Popeyes Louisiana Kitchen  
 400 Perimeter Center Terrace, Suite 1000  
 Atlanta, GA 30346

## Design & Construction Field Bulletin

Date	June 6, 2016 (Issuance #002)
Field Bulletin No.	FB-006 2016 (2 pages)
Category	Roofing
Subject	Durolast Roofing Specification
Prototype Set Referenced	PLK 15 Series Drawings
Prototype Drawings Referenced	Sheets A4 & A7
D&C Contact	design@popeyes.com

1 ROOF PLAN  
A4 1/4"=1'-0"

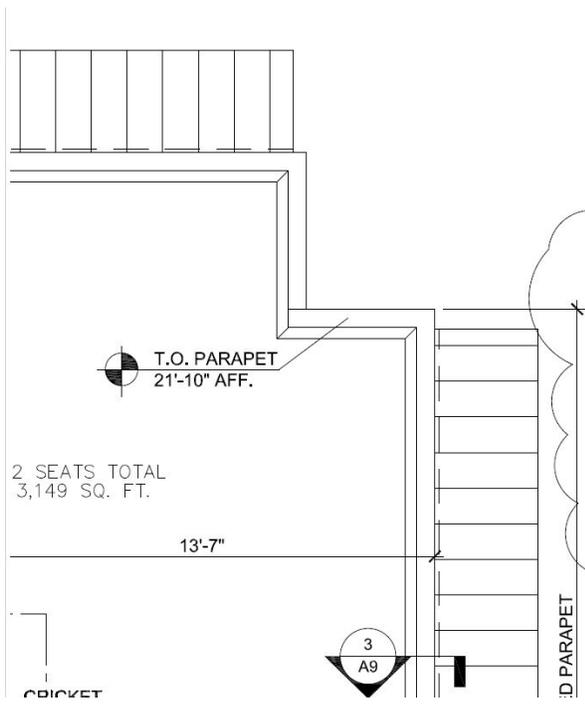
The roofing detail on Sheet A4 does not match the specification on Sheet A7. The detail has been revised to note "ROOFING SYSTEM". In addition, roofing specification on Sheet A7 has been revised.

ROOFING SYSTEM SHALL BE WHITE PVC  
50-MIL MEMBRANE ROOFING AS  
MANUFACTURED BY:

1) DURO-LAST OR EQUAL

PROVIDE OVERALL THERMAL RESISTANCE FOR  
ROOFING SYSTEM AS FOLLOWS: MINIMUM R-VALUE 30.
